REMARKS

This responds to the Office Action dated May 10, 2007 (hereinafter "Office Action"). Claims 1, 10, 13, 18, 21, 26 and 30 are currently amended and fully supported by the application as filed. No claims have been canceled or added. Accordingly, claims 1-32 are currently pending in this patent application.

TITLE: EXTERIOR WOOD COMPOSITE RAISED PANEL
INVENTORS NAME: Brenda J. Brunk et al.
DOCKET NO.: 1261.031US1

Fig. 4

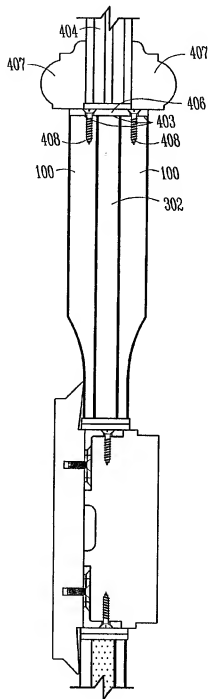
1. The drawings were objected to under 37 CFR 1.84(p)(5). In accordance with the textual portions of the application as filed, such as at page 9, Applicants have amended FIG. 4 to include the reference numeral "400" to refer generally to the panel assembly shown therein.

400 →
